TECHNICAL MEMORANDUM (FINAL VERSION)

Date: October 8, 2019

Subject: **Supplement No. 3 to Citywide Storm Drainage Master Plan
Lammers and Mountain House Watersheds**

Exhibit A – Portion of Figure 5-1A from Existing Citywide Storm Drainage Master Plan Showing Existing and Proposed Storm Drainage Facilities in the City's Lammers and Mountain House Watersheds

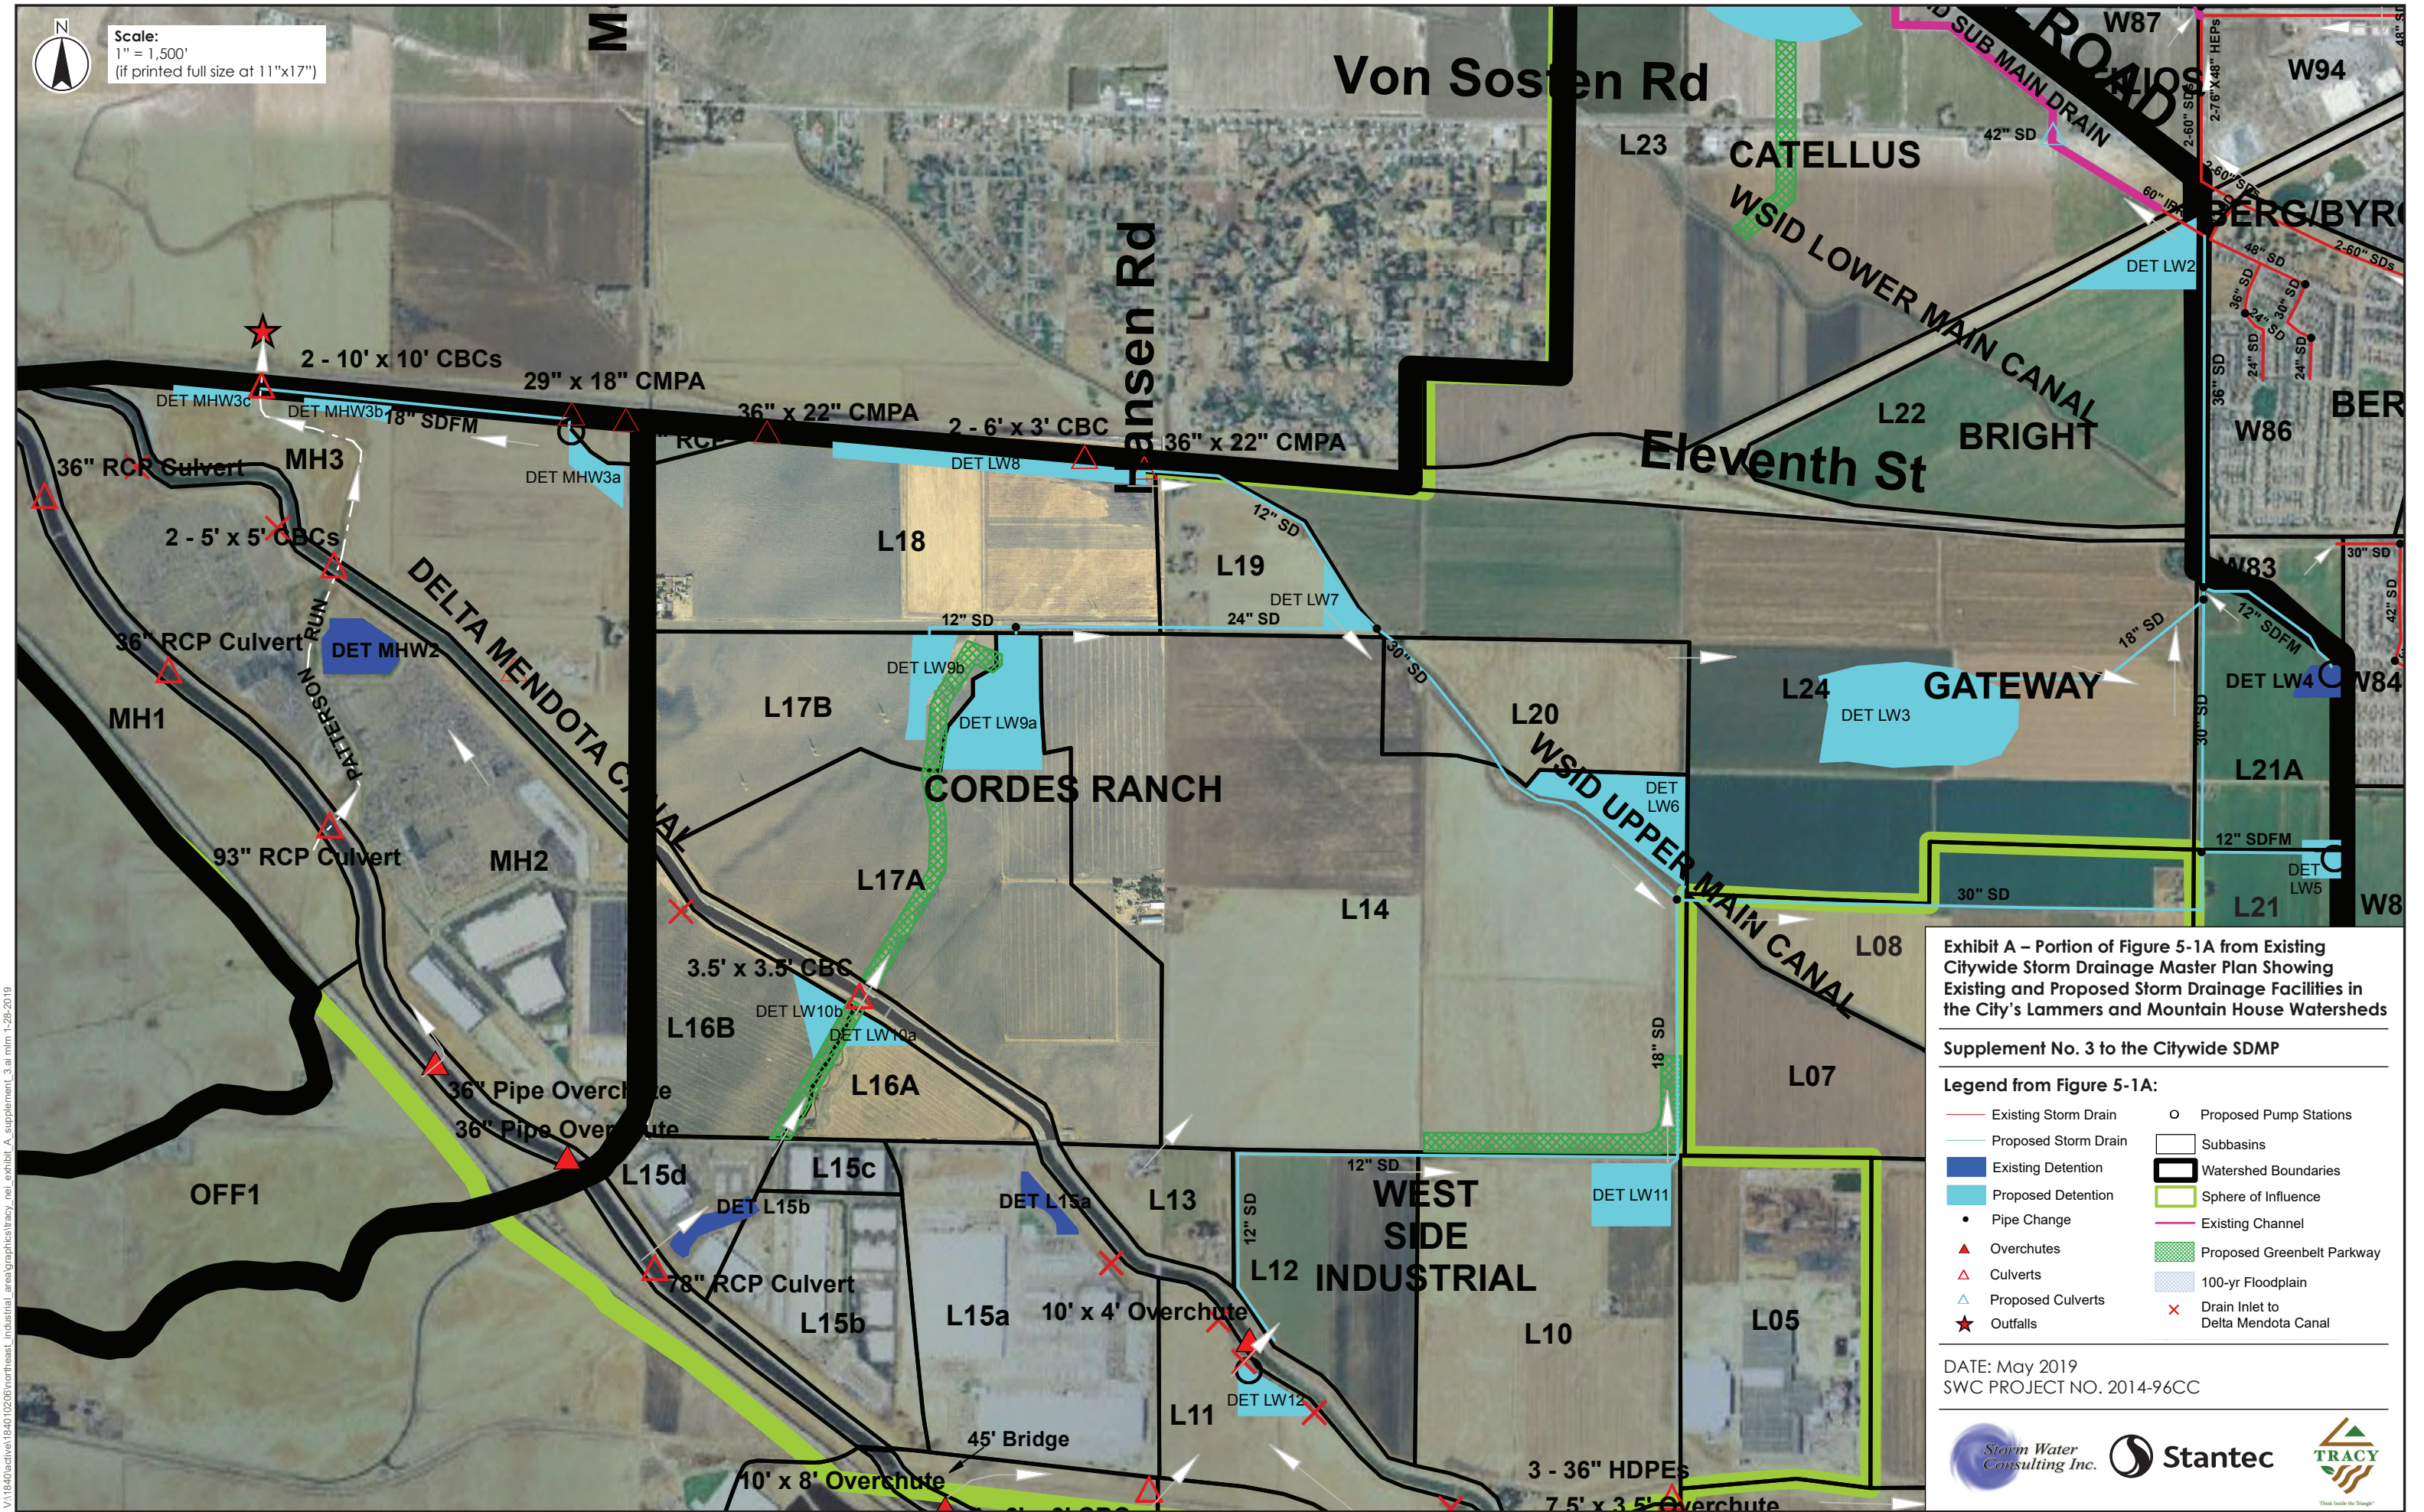
Exhibit A is a portion of Figure 5-1A from the Citywide SDMP that depicts the existing adopted storm drainage plan for the broader portion of the City where changes and updates are being proposed with this Supplement No. 3. The area to be served includes Cordes Ranch, various International Park of Commerce existing and proposed development areas, the property formerly known as the Gateway property, and other properties in the area.

Exhibit B – Proposed Revisions to the Existing Citywide Storm Drainage Master Plan per Supplement No.3

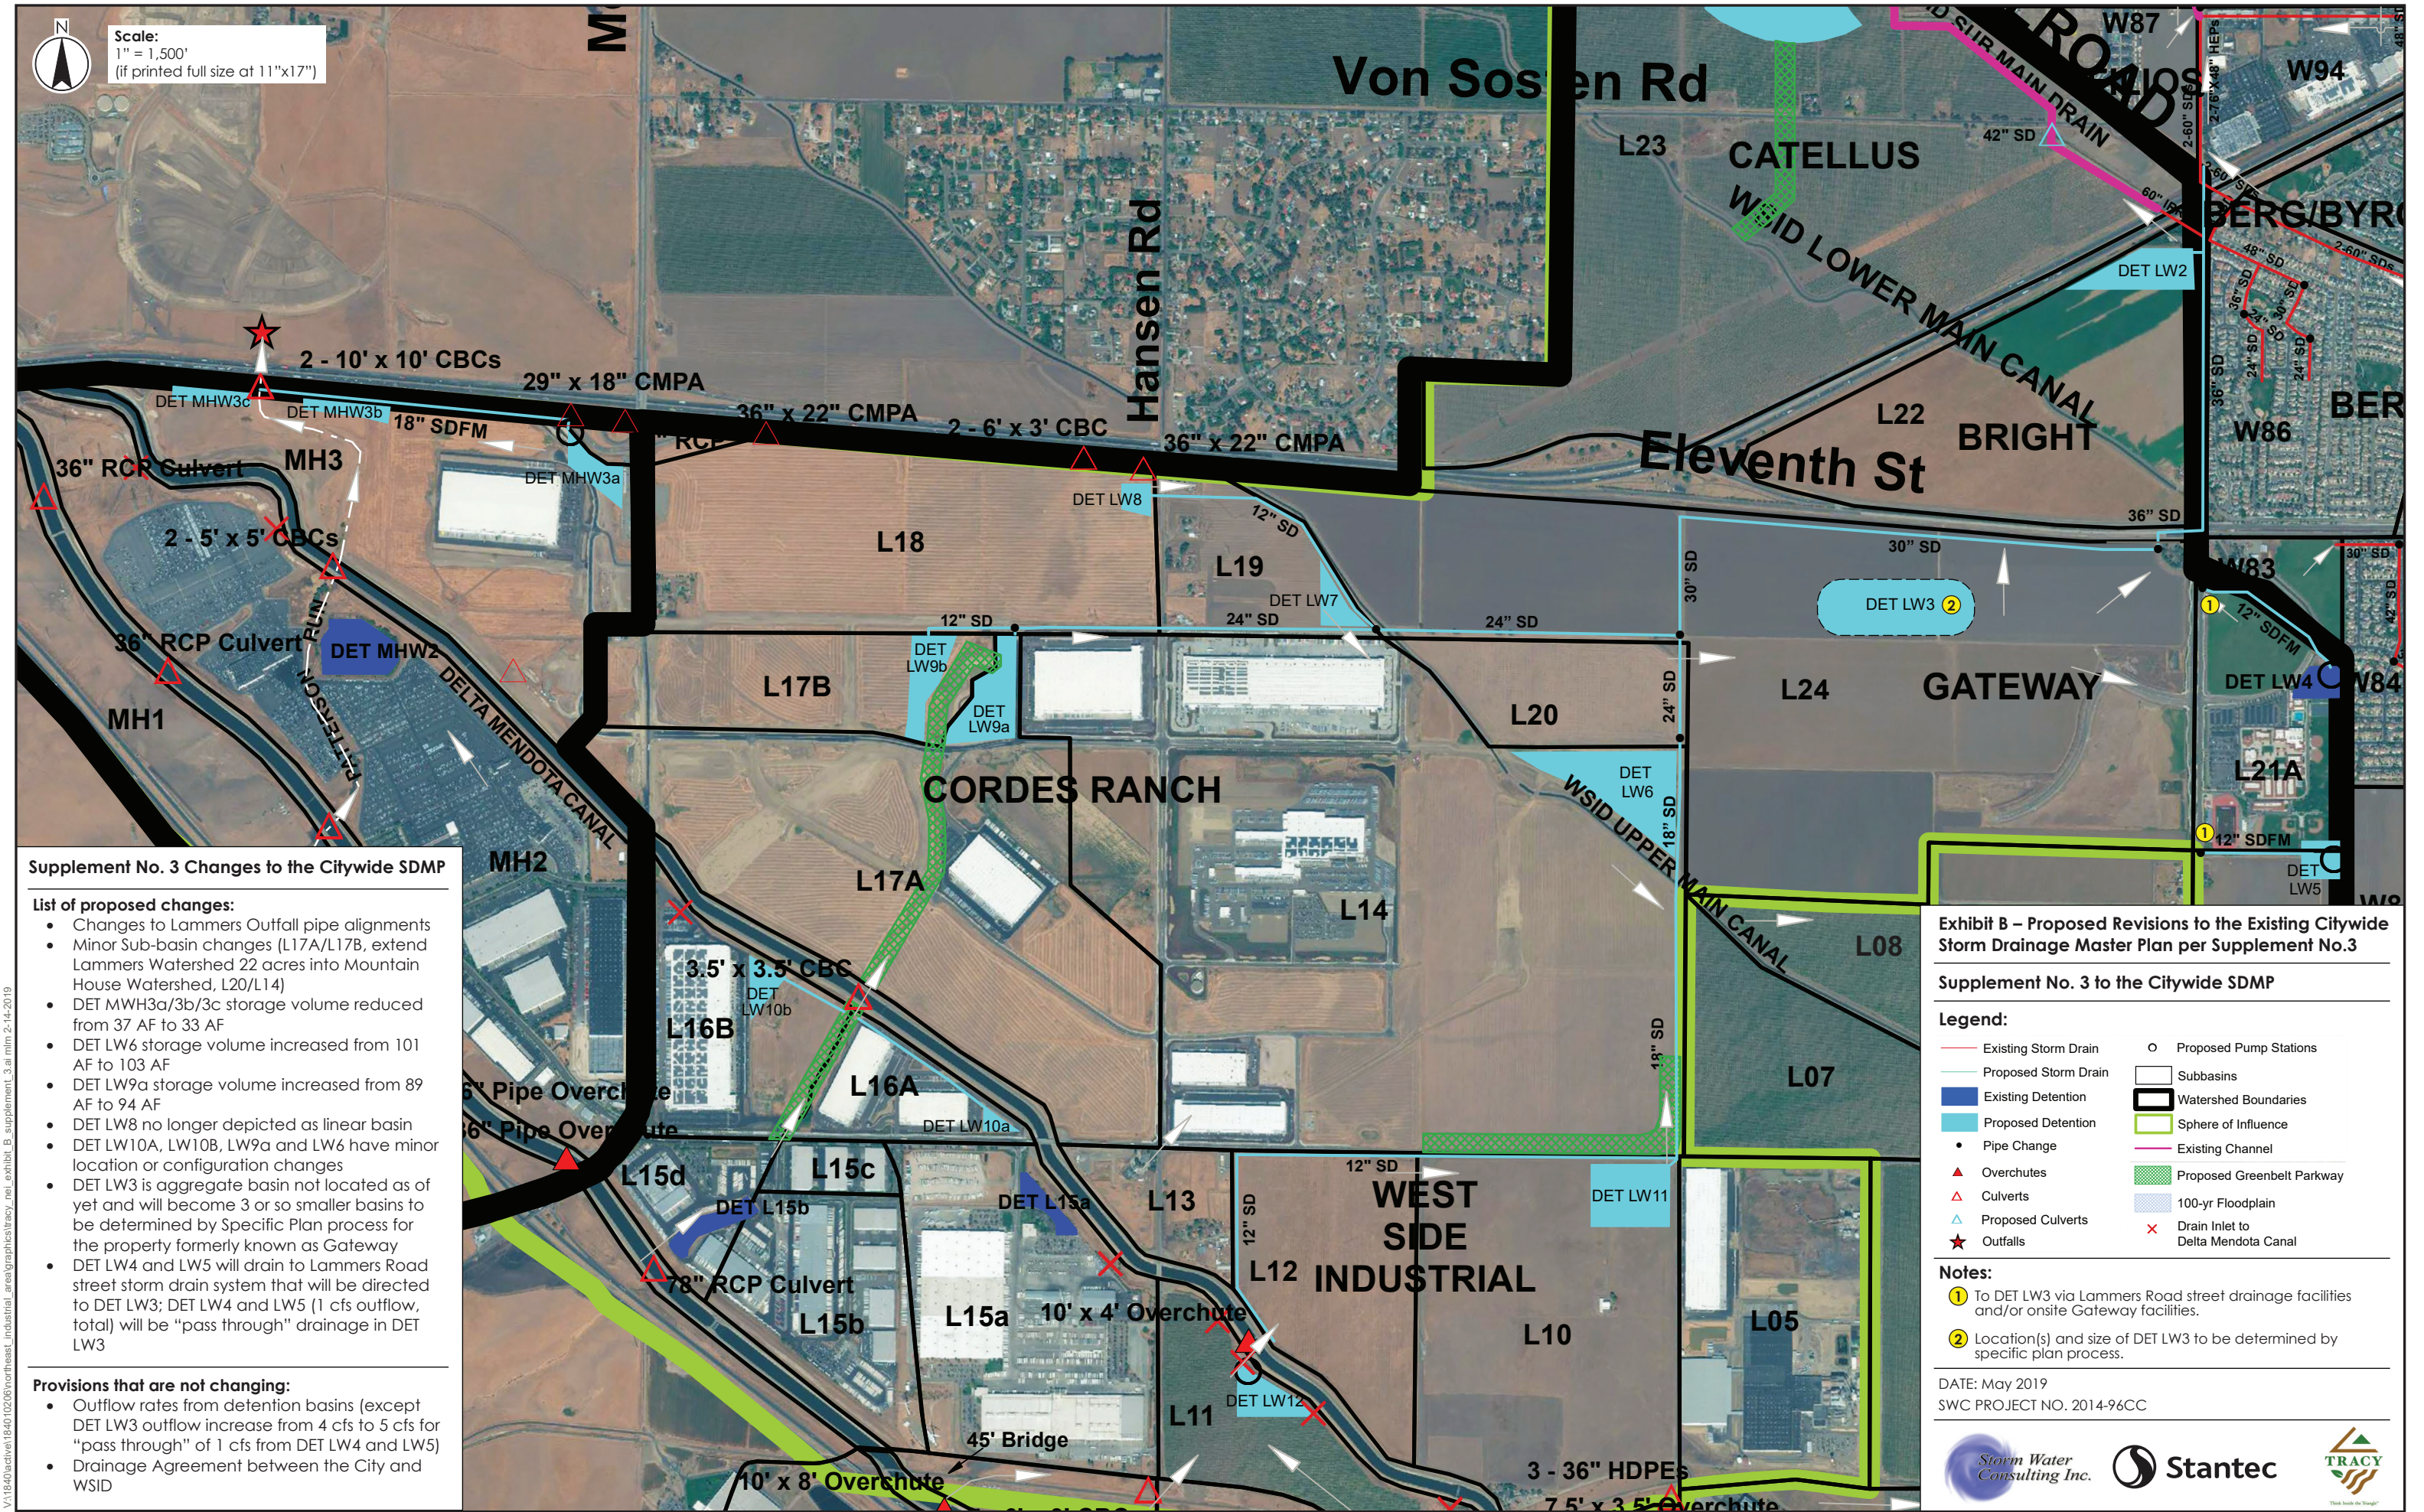
Proposed updates to program storm drainage infrastructure and minor adjustments to Sub-basins and Watershed boundaries proposed per this Supplement No. 3 to the Citywide SDMP are depicted and listed on Exhibit B and include the following:

- Changes to the alignment of selected segments of the Lammers Outfall Storm Drain system.
- Minor Sub-basin changes (L17A/L17B, transfer 22 acres of the Mountain House Watershed into the Lammers Watershed, L20/L14).
- DET MWH3a/3b/3c storage volume is reduced from 37 acre-feet (AF) to 33 AF due to a 22 acre reduction in the contributing drainage area per the watershed adjustment cited above.

- DET LW6 storage volume is increased from 101 AF to 103 AF due to minor sub-basin changes (L20/L14).
- DET LW9a storage volume is increased from 89 AF to 94 AF due to minor sub-basin changes (L17A/L17B) and watershed adjustments.

- DET LW8 is no longer depicted as a linear basin.
- DET LW10A, LW10B, LW9a and LW6 have minor location or configuration changes.
- DET LW3 is shown as an aggregate basin not located as of yet and will become three (3) or so smaller basins to be determined by the Specific Plan process for the property formerly known as Gateway.

- DET LW4 and LW5 will drain to the existing Lammers Road street storm drain system and/or future onsite storm drainage facilities serving the property formerly known as Gateway that will be directed to DET LW3; DET LW4 and LW5 (1 cfs outflow, total) will be “pass through” drainage in DET LW3 and will not affect the DET LW3 storage volume.

- List of proposed changes:**
- Changes to Lammers Outfall pipe alignments
 - Minor Sub-basin changes (L17A/L17B, extend Lammers Watershed 22 acres into Mountain House Watershed, L20/L14)
 - DET MWH3a/3b/3c storage volume reduced from 37 AF to 33 AF
 - DET LW6 storage volume increased from 101 AF to 103 AF
 - DET LW9a storage volume increased from 89 AF to 94 AF
 - DET LW8 no longer depicted as linear basin
 - DET LW10A, LW10B, LW9a and LW6 have minor location or configuration changes
 - DET LW3 is aggregate basin not located as of yet and will become 3 or so smaller basins to be determined by Specific Plan process for the property formerly known as Gateway
 - DET LW4 and LW5 will drain to Lammers Road street storm drain system that will be directed to DET LW3; DET LW4 and LW5 (1 cfs outflow, total) will be "pass through" drainage in DET LW3

- Provisions that are not changing:**
- Outflow rates from detention basins (except DET LW3 outflow increase from 4 cfs to 5 cfs for "pass through" of 1 cfs from DET LW4 and LW5)
 - Drainage Agreement between the City and WSID
